ST-HL-AE-1389

South Texas Project  
Units 1 and 2  
Docket Nos. STN 50-498, STN 50-499  
Responses to DSER/FSAR Items Regarding Section 3.6

### 3.6 PROTECTION AGAINST THE DYNAMIC EFFECTS ASSOCIATED WITH THE POSTULATED RUPTURE OF PIPING

Figure 3.6.1-1 SH 3A

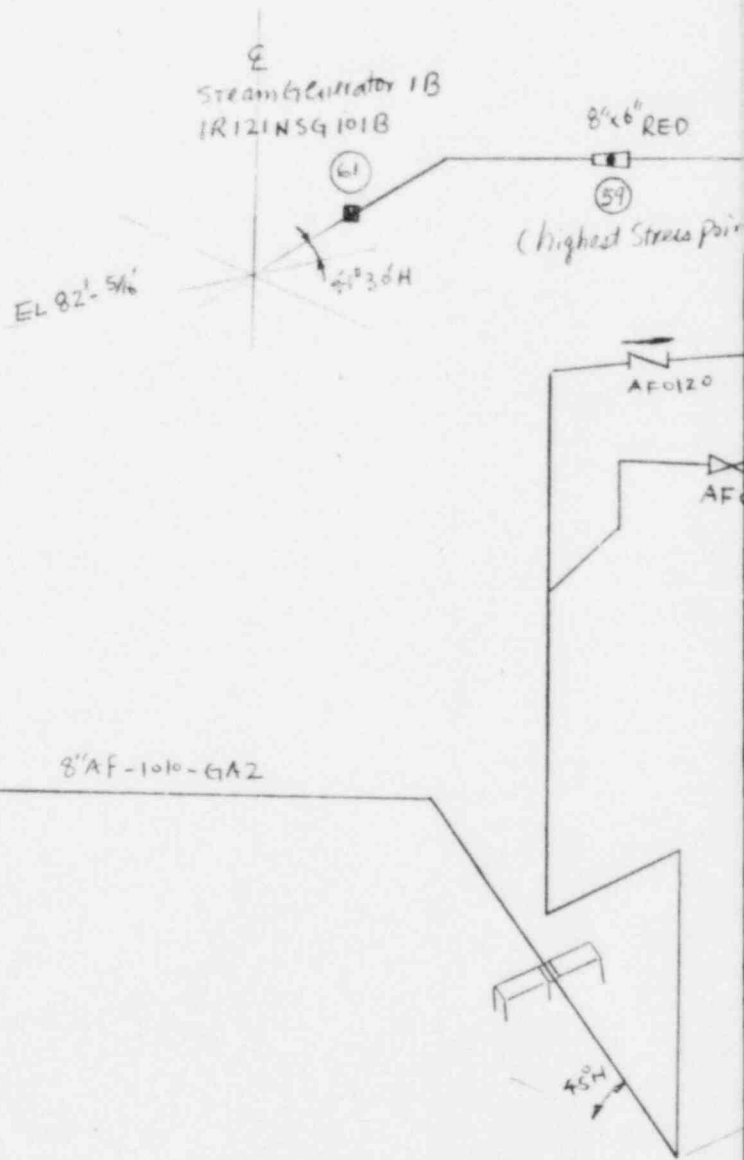
In order to assure that the pipe break criteria have been properly implemented, the Standard Review Plan requires the review of sketches showing the postulated rupture locations and of summaries of the data developed to select postulated break locations including, for each point, the calculated stress intensity, the calculated cumulative usage factor, and the calculated primary plus secondary stress range. The required sketches and tables for some high energy piping systems have not been provided at this time in the FSAR. Provide a schedule for submission of these data.

*are shown in FSAR Table 3.6.2-1. Sketches showing pipe break locations are provided in FSAR Figure 3.6.1-1.*  
Initial stress summaries regarding pipe break locations, stress levels, cumulative usage factors ~~will be provided during the fourth quarter of 1985.~~  
Final design information, including as-built reconciliation, will be provided prior to fuel load.

FIGURE 3.6.A-1

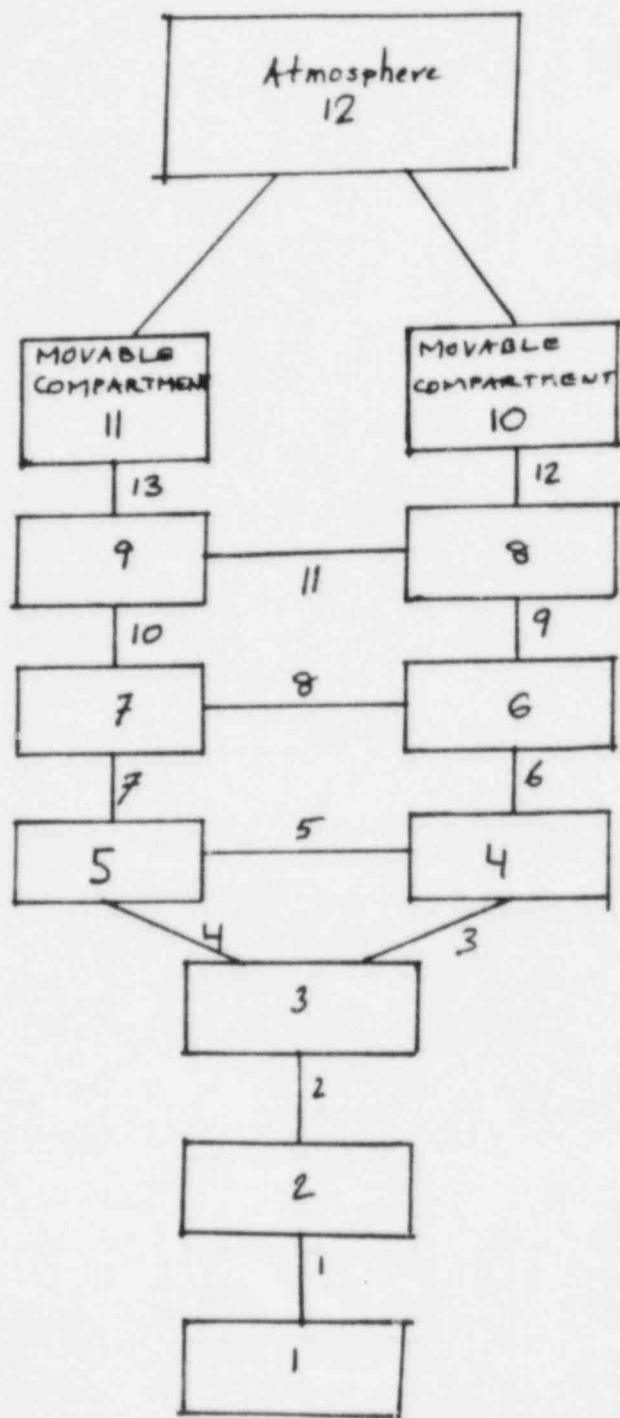
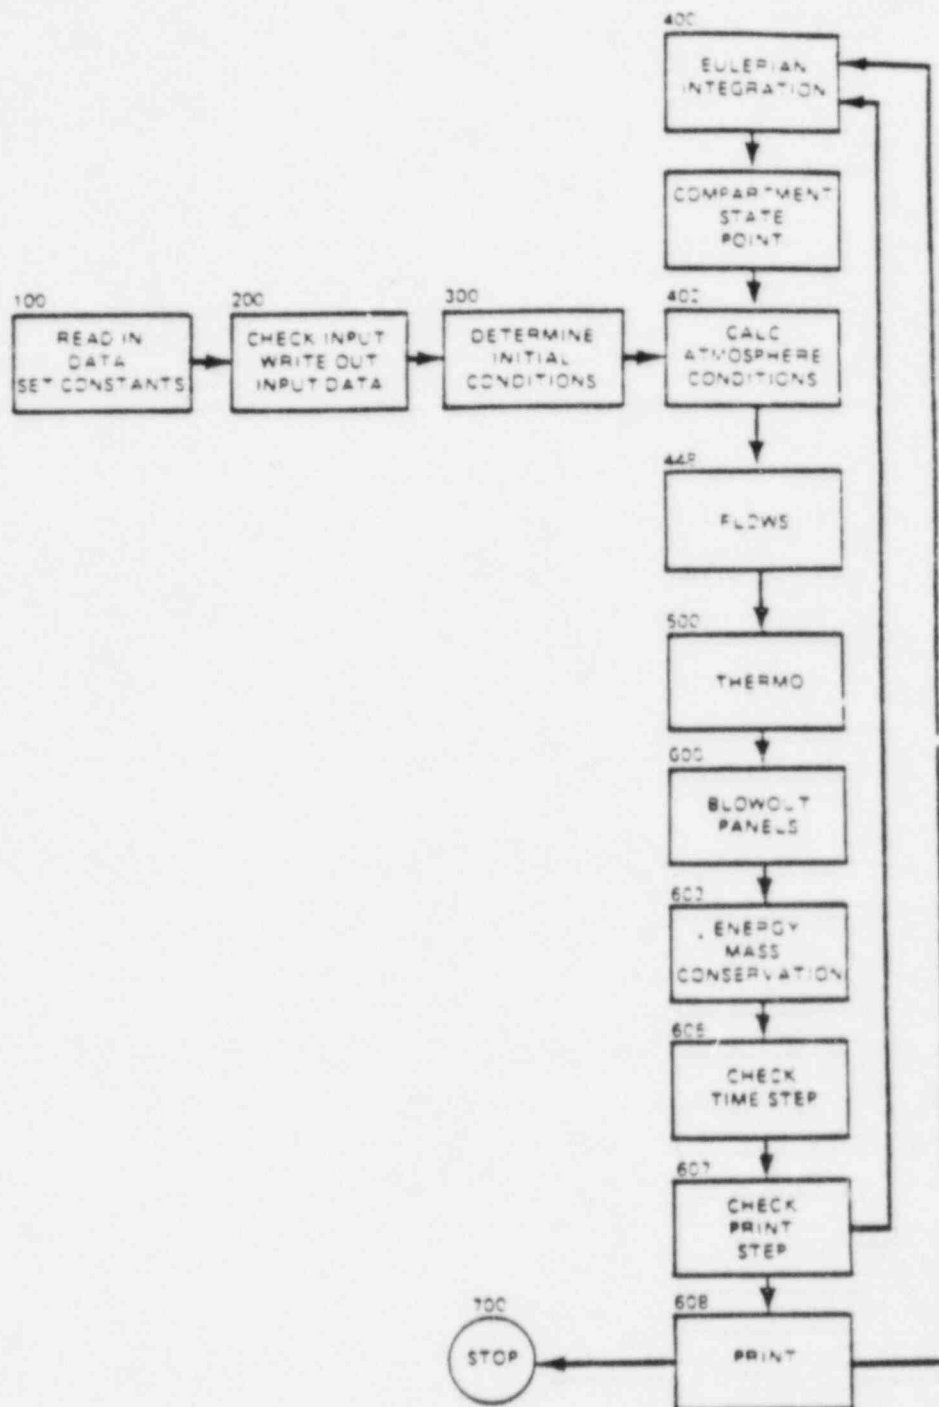
During our review of your Report No. LO1ORR064A, "Report on Dynamic Effects of Postulated Piping Failures Outside the Containment," you proposed to redesign your main steam and feedwater valve compartment to consider the environmental effects (pressure, temperature, humidity) and potential flooding consequences from an assumed crack, equivalent to the flow area of a single ended pipe rupture in these lines inside the valve compartment. Provide your design modification and the related safety analysis, including the following:

1. Describe the location and size of the vent areas in the main steam and feedwater valve compartment.
2. We require that essential equipment located within the compartment including the main steam isolation and feedwater valves and their operators be qualified to operate in the environment resulting from the above assumed single ended pipe rupture. State your intent with regard to this position.
3. Provide a subcompartment pressure analysis to confirm that the design of the main steam and feedwater valve compartment can withstand the effects of the above assumed single ended pipe rupture. When you submit the subcompartment pressure analysis, identify the computer code used, the assumptions used for mass and energy release rates, the length of time blowdown exists, and sufficient design data so that we may perform independent calculations.

As discussed in revised Section 3.6, an Appendix will be provided that describes the evaluations made of the effects of postulated pipe failures within the plant. A discussion of the effects of postulated failures within the Isolation Valve Cubicle ~~will be included~~ <sup>is provided in FSAR</sup>
